A. RO Inspection Report No. 050-331/74-07

RO Inspection No. 050-331/74-07

Duane Arnold Energy Center
Palo, Iowa

Type of Inspection: Special, Announced Follow-up Industrial Security
Inspection

EXHIBIT C

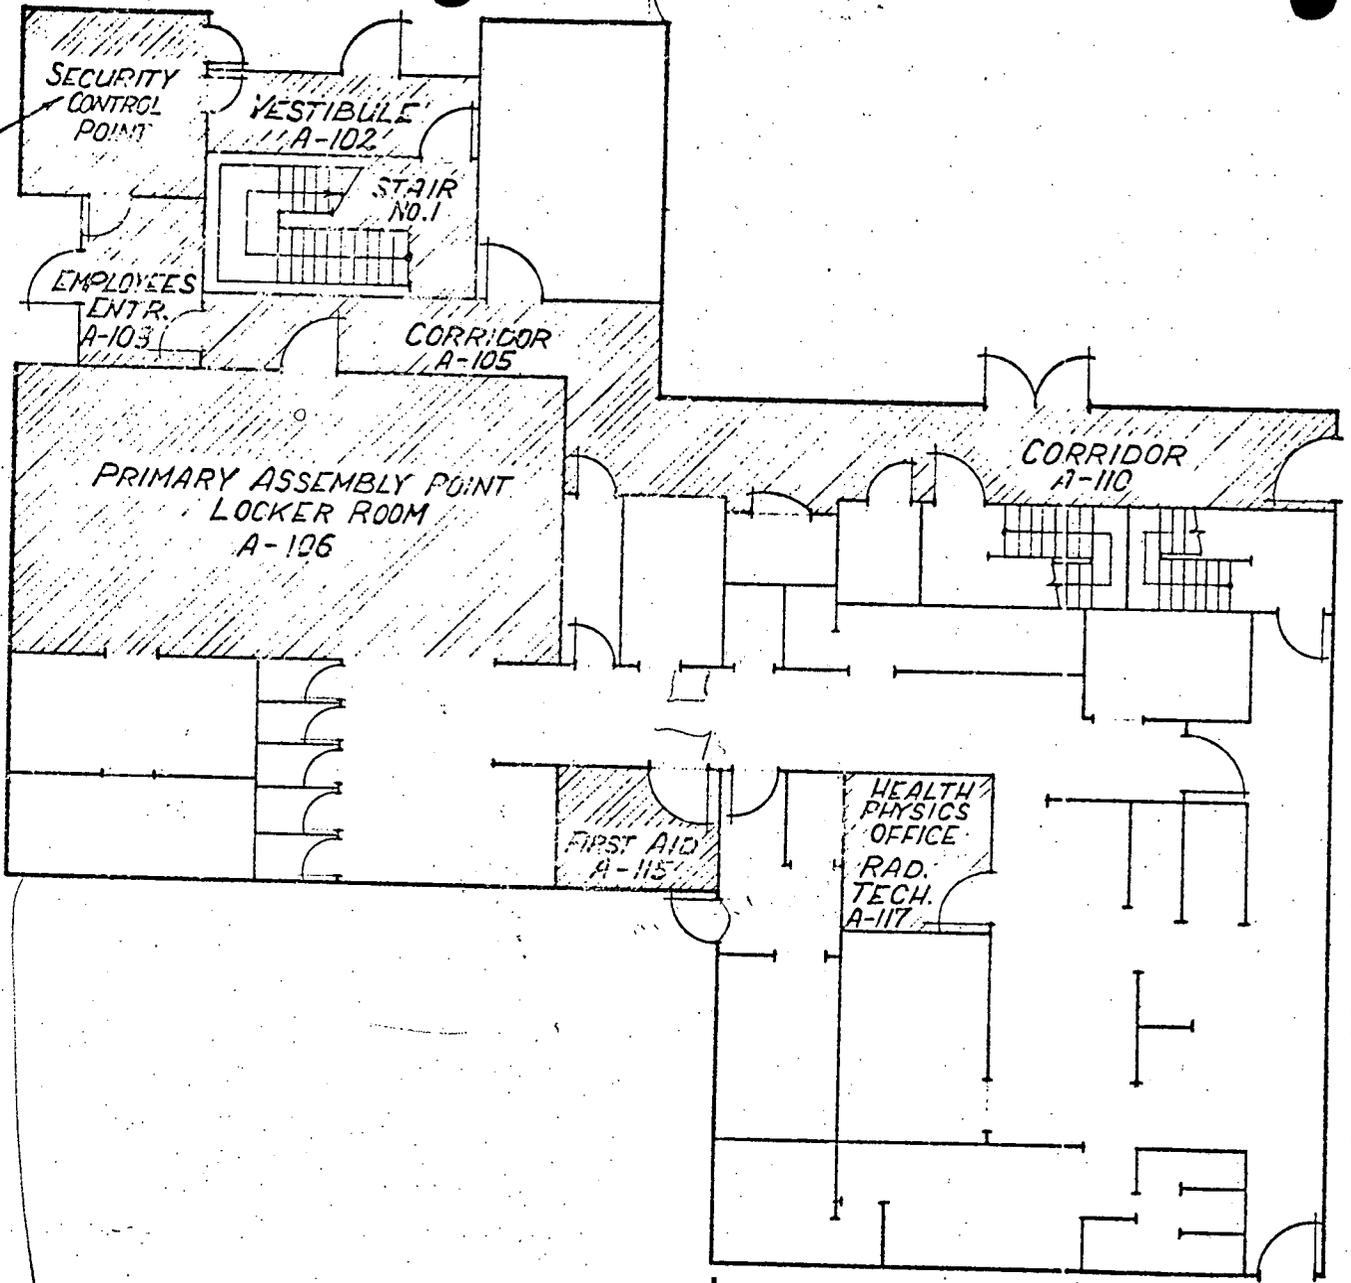
lines under the fence have been fitted with steel rebars wired to prevent spreading. The fence has been posted with "No Trespassing" signs at 100' intervals. Inside the fence of the protected area are temporary trailers and buildings which are within the isolation zone and construction debris was noted both inside and outside of the fence. The DAEC Security Plan, Section 2.1.1.2, states that the isolation zone (10 feet inside and 25 feet outside the fence) is maintained clear of all objects that could be used to conceal a person. The temporary trailers and structures are utilized to house construction personnel and equipment. Assurances were provided that as soon as construction is completed, the trailers would be removed, the temporary buildings dismantled and the scrap and rubble removed from both sides of fence. Drawings of the plant site and first floor layout are attached as Exhibits A and B. Work was being completed in the SCP by installation of controls for electrical sticker locks for the employee and visitor entrances. Also, the alarm annunciator and off-site radio were installed but not completely tested for effectiveness and operability. It was determined by the principal inspector, subsequent to this inspection, that the SCP construction has been completed, the post is manned to control access and the alarm annunciator and communications equipment were tested and are operable. A drawing depicting the security control point is attached as Exhibit C.

To observe the activities in the SCP, there is a CCTV camera positioned near the ceiling which views the watchman and the two portals through which persons enter. The monitor is situated in the Control Room.
